MONTGOMERY COUNTY HISTORIC PRESERVATION COMMISSION
STAFF REPORT

Address:	8017 Hampden Lane., Bethesda	Meeting Date:	2/26/2020
Resource:	Contributing Resource Greenwich Forest Historic District	Report Date:	2/19/2020
Applicant:	Mark and Marjorie Kramer Mark Kramer, Architect	Public Notice:	2/12/2020
Review:	Preliminary Consultation	Staff:	Dan Bruechert
PROPOSAL:	Entrance Removal, Rear Addition, Tree Removal

○ EXISTING - DEMO / FRONT ELEVATION
SCALE: 1/8"=1'-0"

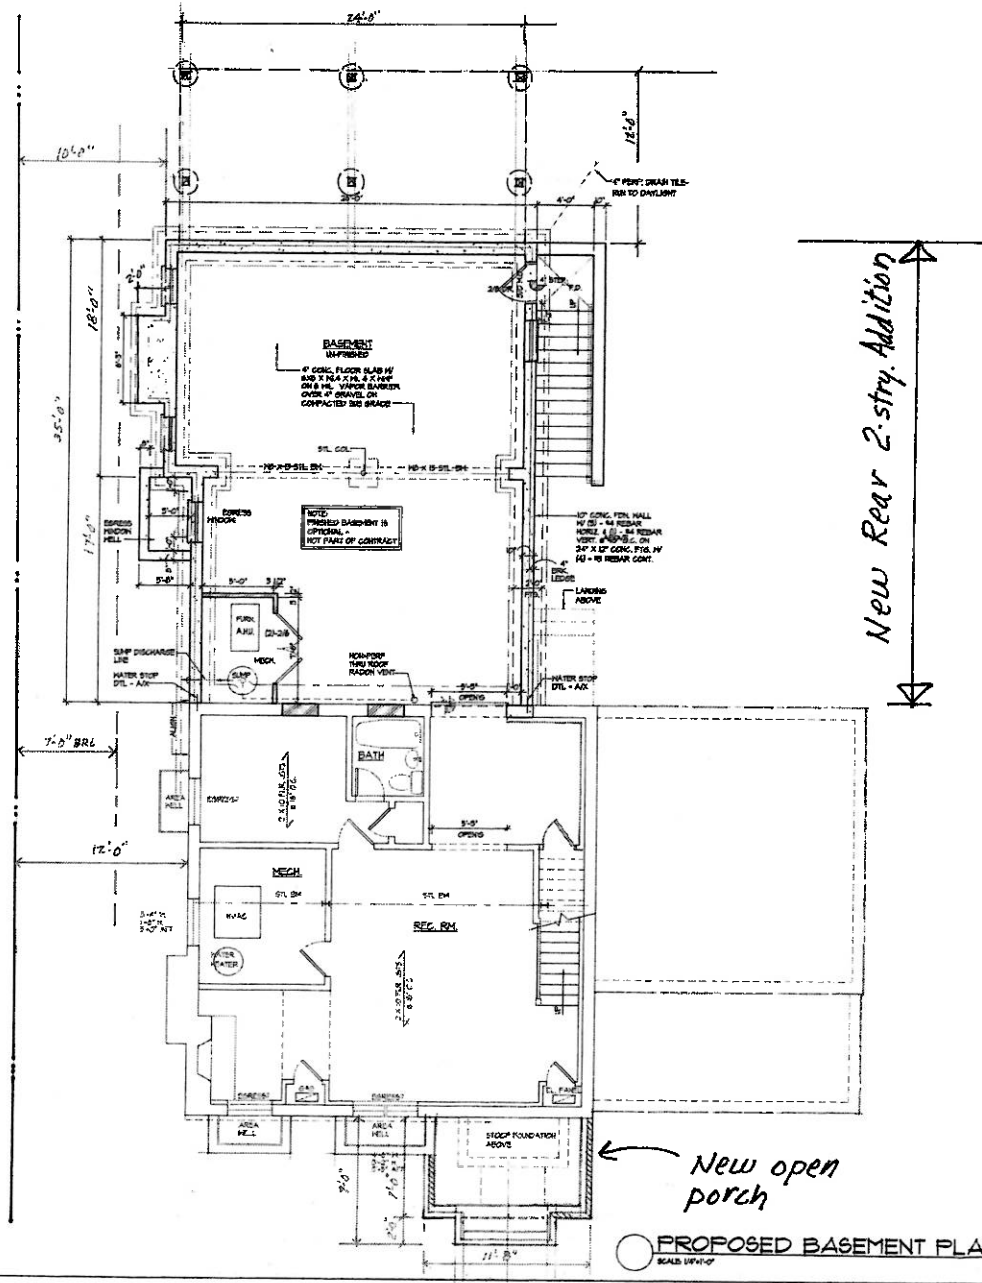
The historic front entry has a standing seam copper roof supported by wrought copper brackets. The applicant proposes removing this entrance and installing a new porch with a copper shed roof, supported by wood posts and brackets, copying the design found on the front elevation of the one-story section of the house to the right. This is a design element that is found throughout the historic district.

In place of the existing entrance, the applicant proposes installing a new porch that will match the dimensions of the existing front stoop. The stoop projects 7' (seven feet) from the front wall and is 11' 8" (eleven feet, eight inches) wide. The copper shed roof will be supported by square wood posts with brackets matching the house elevation to the right. The applicant included drawings and photos of a model of the new roof with the application materials.

Staff finds that the character of the house consists of the many Tudor details including the heavy wood lintel over the ganged first-floor window, diamond window pattern, and decorative stonework. Additionally, the proportion of the applied decorative elements is consistent throughout the house, including the wall and shed dormers, front entrance hood, and timbering. Staff finds the proposed materials for the new porch are consistent with both the house and surrounding district. The existing entrance is covered in copper and there is wood timbering found on the house and throughout the surrounding district. Staff has two concerns with this proposal: whether the design and shape of the porch is compatible with the character of the house and if the size and massing are appropriate. Staff notes the existing entrance only covers a small section of the front stoop above the front door. The proposed shed porch roof will cover the entire front stoop, approximately tripling the size of the front entrance. Additionally, the proposed shed roof will

intersect the wall at the second-floor sill level and create a new, prominent feature that is approximately 18” (eighteen inches) taller than the existing entrance hood. Staff finds that the proposed size and massing may be too large for the size and scale of the historic house and the design may be too blocky to be compatible with the historic house.

- Removing the existing front entrance;
- The appropriateness of the proposed front porch materials;
- The appropriateness of the proposed front porch design; and
- The appropriateness of the proposed front porch size and massing.

SHEET TITLE:
PROPOSED ELEVATIONS

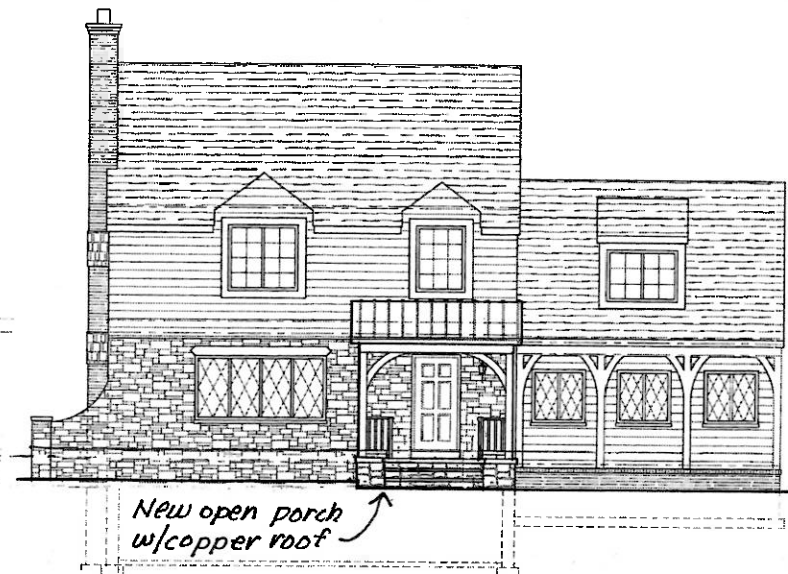
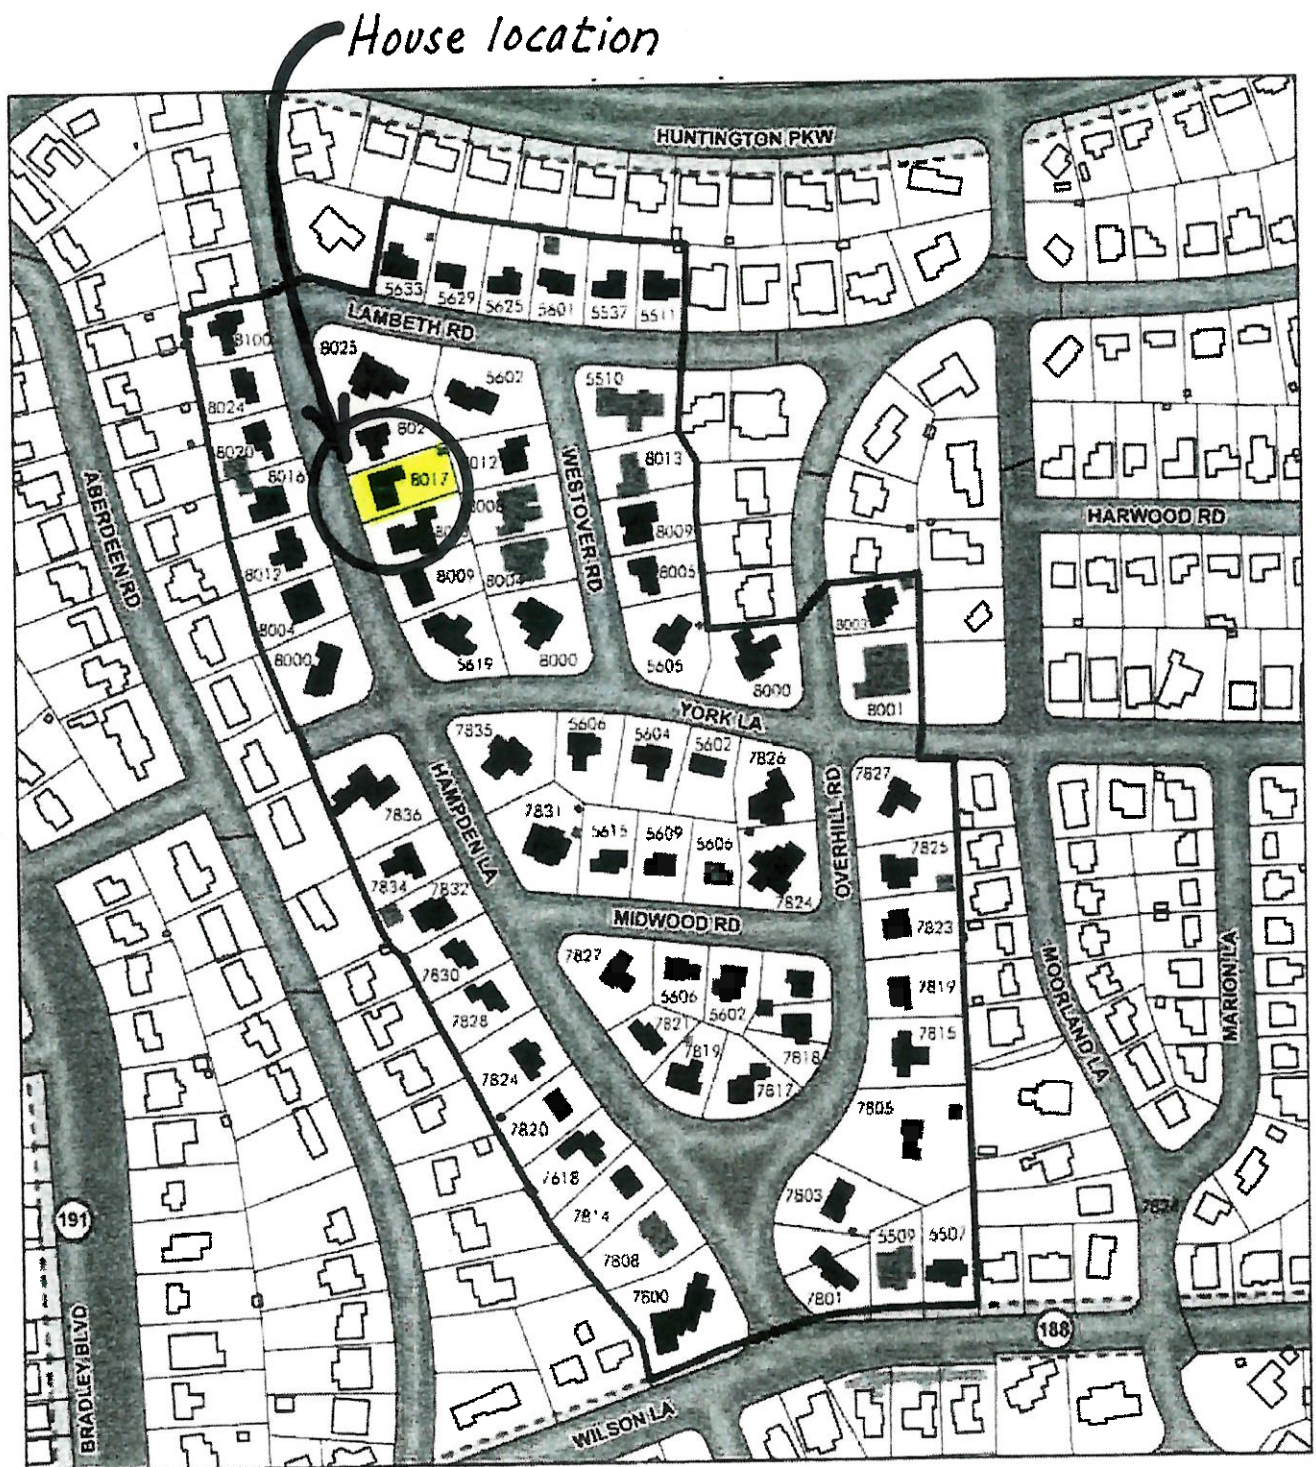
In place of the existing one-story addition, the applicant proposes installing a new two-story rear addition with a full basement. The siding of the proposed addition will match the siding found on the second floor of the historic house. The asphalt shingle roofing will match the roofing installed on the historic house.

The Greenwich Forest *Design Guidelines* offer significant flexibility when it comes to additions to contributing and non-contributing resources. Additions to contributing resources must “preserve as a recognizable entity the outline of the original house...” and the house must be a matching style, and the addition’s ridgeline must be lower than the historic principle ridgeline. The *Guidelines* also place a maximum lot coverage of 25%. As this is a requirement of the *Design Guidelines* and not a zoning requirement alone, this calculation is required for a HAWP application to be considered complete. Staff finds that the proposed addition is the same style as the historic house, as required and that the roof ridgelines are lower than the historic side gable, as required.

The outstanding question has to do with whether or not the addition preserves the historic house as a recognizable entity. Generally, additions have to be inset from the historic wall plane by 1’ – 2’ (one to two feet) depending on the size and scale of the building. In this instance, it appears as though the addition is inset by 6” (six inches) or less. A general requirement of additions to historic houses is that the addition remains within the wall plane of the historic massing. That is not the case in Greenwich Forest and side additions and (side projecting additions) are allowed provided the setback between the two houses is at least 18’ (eighteen feet). The setback between the two houses was not included.

- The design and size of the proposed rear addition;
- The appropriateness of the side projections; and
- Guidance regarding new windows and doors for the rear addition.

Detail: Exist front door with canopy to be replaced with open front porch with copper roof

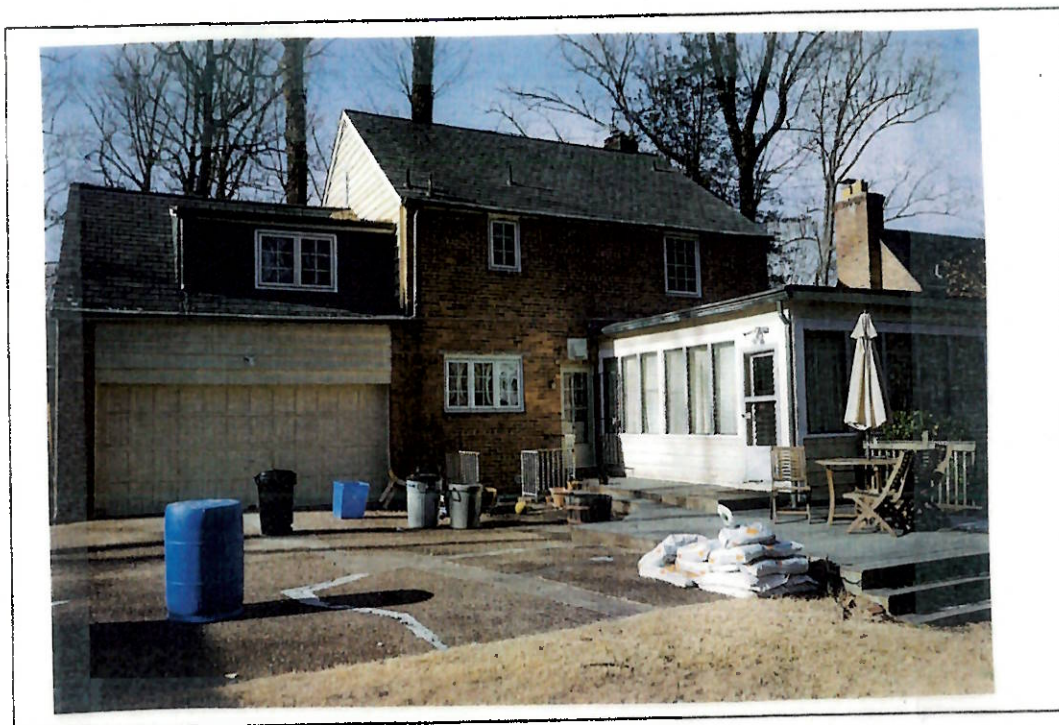
The first question that needs to be answered is whether or not the existing entrance is an architecturally significant feature. In its evaluation of this feature's significance, Staff considers the appearance of the house without the entrance and finds that the form of the house would still contribute to the character of the surrounding district. Staff finds that the loss of the existing entrance could be supported under the *Design Guidelines*, particularly when coupled with the goal of preservation and owner flexibility.
